Design Review Subcommittee (DRSC)

SUBJECT: **Discretionary Sign Permit 17-399, El Camino Real Shell Master Sign Program**, a request to consider a Master Sign Program for an existing service station located at 2400 South El Camino Real.

Image 1 – Spanner Sign

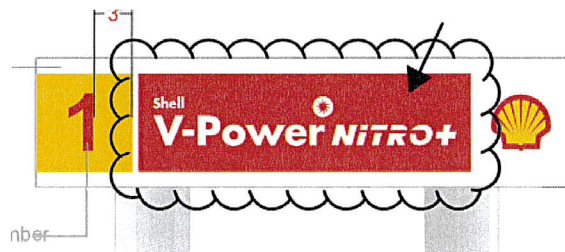
3. Remove the red background identified on Image 1 below from the spanner signs, and use red font for "Shell V-Power Nitro" instead. Since white is a prominent color of Spanish architecture, this will improve architectural compatibility.
